TITLE: SmartMic Circuit Board

Document Number: SM1000-REV-B1 REV: B

TITLE: Smart Mic Circuit Board

Sheet: 2/2

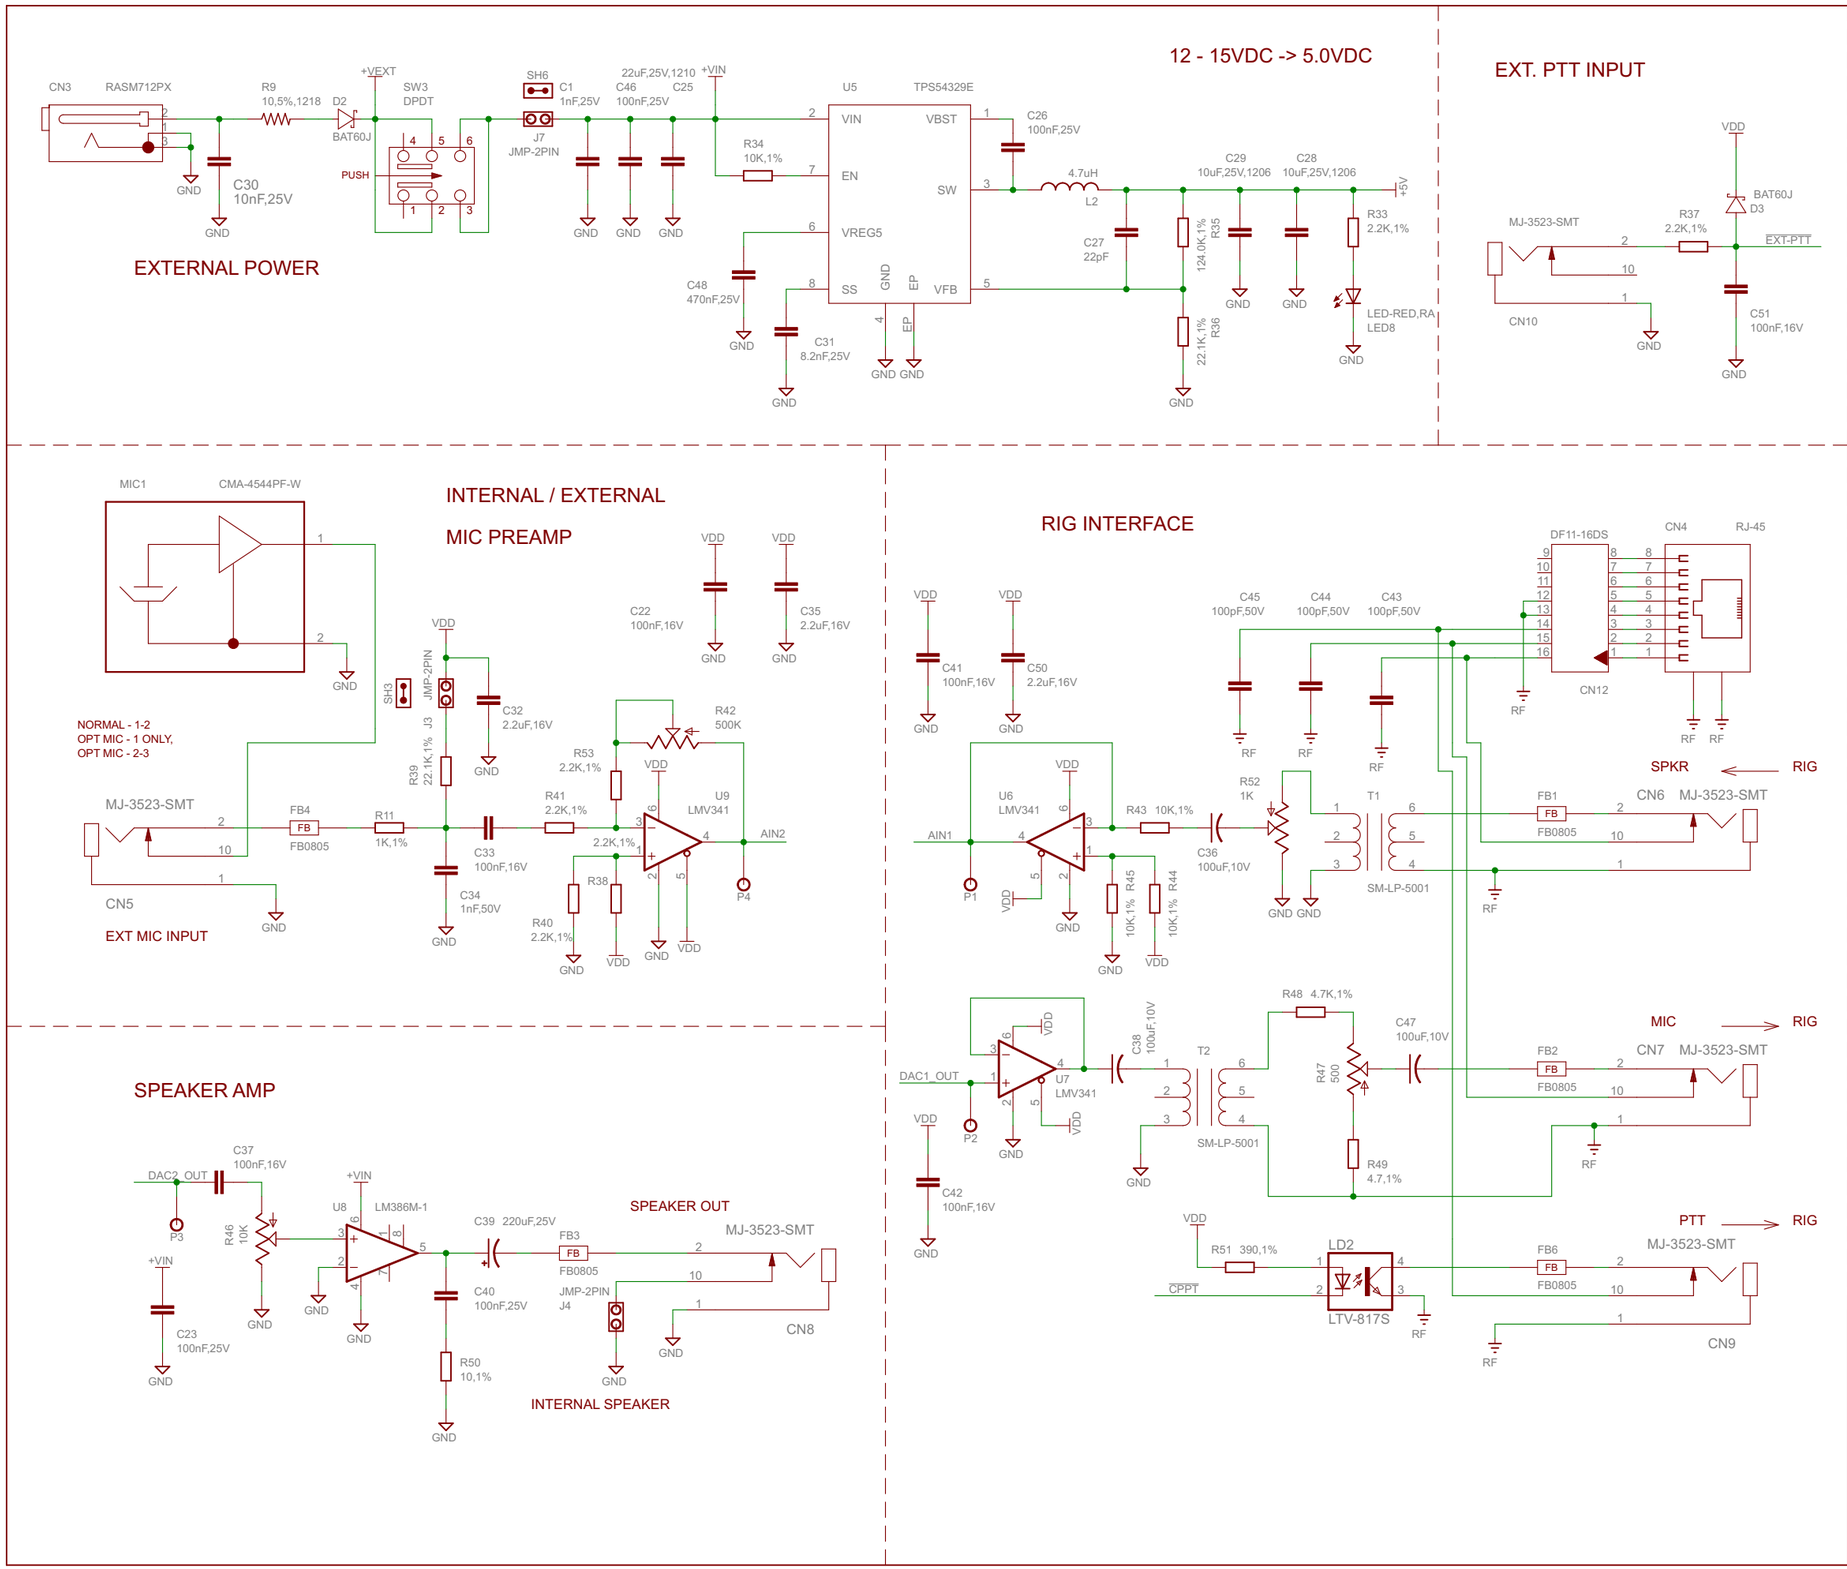
06/17/2014
50. Changed Select & Back circuits to match PTT.
49. Changed C34 to 1nF.
48. Aded 1K resistor in series with FB4.
47. Replaced FB5 with 10 Ohm 1206 Wide resistor.
46. Ad 10nF cap across CN3.
45. Added 1nf cap in parallel with C46.

06/16/2014
44. Add test point P20 (+VIN).
43. Add test point P19 (+5V).
42. Add test points P13,p15,p17 (VDD).
41. Add test points P14,P16,P18 (GND).
40. Add test points at pins 24,25,29,30. AIN1,AIN2,DAC1,DAC2
39. Add test points at pins 97,98,1,2. PE0,PE1,PE2,PE3
38. Add test points at pins 77,78,79,80. PA15,PC10,PC11,PC12

06/15/2014
37. Change GND on CN12-12,13 to RF
36. Change C39 to 220uF,25V
35. Move Pot R52 to T1 output & change to 1K.
34. Change C40 to 25V.
33. Change C27 to 22pF.
32. Change C2 & C3 to 20pF.
31. Correct pinout for LD3985.
30. Change R1, R7 & R8 to 10K
29. Change R12, R13, R15, R16 & R17 to 680 Ohms.
28. Change C8 to 10nF.
27. Change C10 & C12 to Ceramic 0603 caps.
26. Remove signals from pins 9 & 10 CN12.

06/12/2014
25. Change SW3 back to PBH2UUENAGX
24. Change D3 to BAT60

06/05/2014
23. Change 0603 caps to IPC packages & symbols.
22. Change 0603 resistors to IPC packages & symbols.

06/02/2014
21. Add SELECT & BACK switches.

06/01/2014
20. Delete VUSB Led & circuitry.
19. Delete USB fault LED & circuitry.
18. Delete STLINK LED & components.
17. Change SCL, SDA pulldowns to pullups.

05/29/2014
16. Change CN1 to 3-pin
15. Power electret mic from VDD
14. Change Reset switch to header.

05/28/2014
13 Added PTT SW network to permit DFU mode on power up.
12. Change C23 to 25V.
11. Change C43, C44, C45 to 100pF
10. Add hdr for speaker.
9. Change bypass caps to mix of 100nF and 10nF.
8. Change processor from STM32F407 to STM32F405.
7. Change PCB from 4 layer to 2 layer.
6. Bring GND, RF(GND) & +VEXT to IC1 connector.
5. Add ext. PTT connector and cpu DI.
4. Change mic preamp circuit to op-amp per DR.
3. Change rig mic amp circuit to pot on transformer output.
2. Move LED8 to 5V
1. Change U5 TPS54329E to RT8250
